UNITED STATES PATENT AND TRADEMARK OFFICE

10/705,553

Office Action Summary	Application No. 10/705,553	Applicant(s) MARUYAMA, YASUSHI 	
	Examiner W. David Coleman	Art Unit 2823

DETAILED ACTION

[Drawing 3]

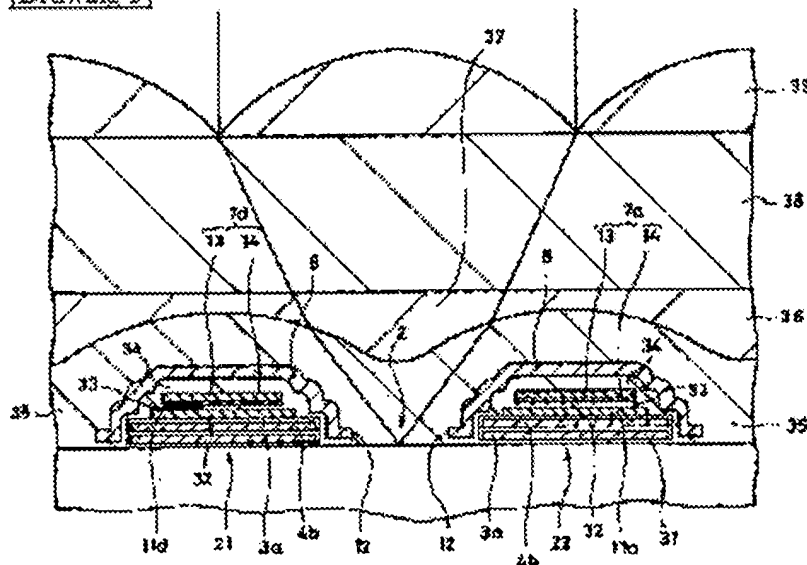
Maruyama discloses a semiconductor process as claimed. See drawings 1-6 where Maruyama teaches the following limitations.

4. Pertaining to claim 10, Maruyama teaches a method of fabricating a solid state image pickup device, comprising the steps of:

providing an insulating film **34** covering a conductive pattern **11d** formed above a substrate **22** with a contact window **6d** reaching said conductive pattern,

covering the bottom surface of said contact window with a thin film comprised of at least one of silicon oxide and silicon nitride **14**,

forming a metallic pattern above said insulating film and in said contact window, and

performing a heat treatment to cause said thin film and said metallic pattern to react with each other [see paragraph 0046].
